AMENDMENTS TO THE SPECIFICATION

Page 35, delete last paragraph (previously presented), and replace with:

AMENDMENT UNDER 37 C.F.R. § 1.114(c)
U.S. Appln. No. 09/649,013

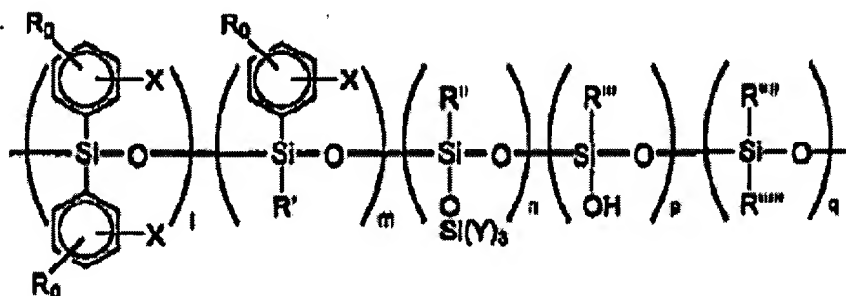
Examples of the resist materials, which may be employed for the second resist layer 32, include the resist materials described in U.S. Patent Nos. 5338818, 5422223, 5866306, 5385804, 5399462, 5238773, 4481049, 4689289 and 4822716; and EP No. 229629A1. Further, the resist materials shown in the following formula, which are disclosed in Japanese Unexamined Patent Publication No. 7(1995)-114188, can be employed for the second resist layer 32.

The photosensitive resin composition contains polysilane having a structure represented by the formula (in which each of R1-R4 is independently selected from the group consisting of optionally substituted aliphatic, alicyclic and aromatic hydrocarbon groups, and each of m and n is an integer), an optical radical generating agent and an oxidizing agent. Further, the resist materials shown in the following formulae, which are disclosed in Japanese Unexamined Patent Publication No. [[2002]] 11(1999)-20224, can be employed for the second resist layer 32.

Formula I

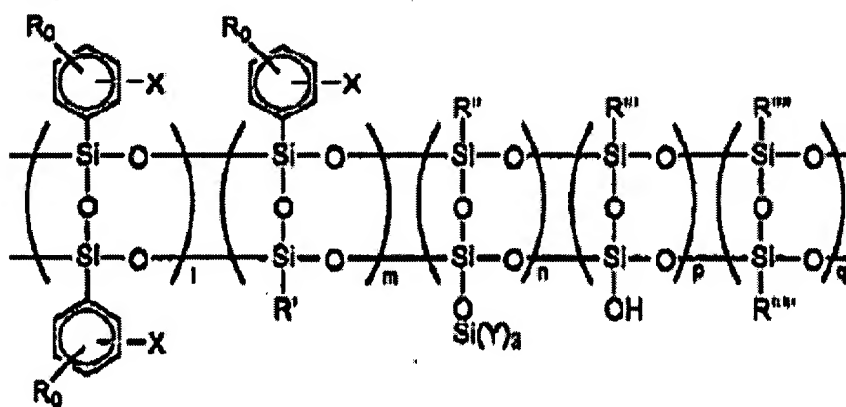
The positive-type silicone-containing photosensitive composition comprising:

(a) a polymer which has a repeat unit expressed with the following general formula (I) and/or (II), and which is water-insoluble and alkali-soluble;

(b) a compound which generates an acid when subject to an activity beam of light or radiation; and

(c) a polymer which has in the side chain thereof a repeat unit expressed with the following general formula (III), the general formula (IV), or the general formula (V), and which exhibits properties that the solubility in an alkali developer increases due to the action of an acid.

(X in formulae (I) and (II) is a group selected from the group consisting of $-C(=O)-R$ group, $-CH(OH)-R$ group, and a carboxyl group, and a plurality of X groups in the formula may be the same or different. R shows a hydrocarbon group which may have a hydrogen atom or a

substitute therein. R'-R'''' may be the same or different, and is selected from the group consisting of an alkyl group, a cycloalkyl machine, an alkoxy group, an alkenyl group, an aralkyl group and a phenyl group all of which may have a hydroxyl group and/or a substituent. Y is an alkyl group, an alkoxy group or a siloxyl machine. R0 represents a group selected from the group consisting of an aliphatic hydrocarbon group and an aromatic hydrocarbon group which may have a hydrogen atom, a halogen atom and/or a substituent. Each of l, m, n and q is 0 or a positive integer, and p is a positive integer.)
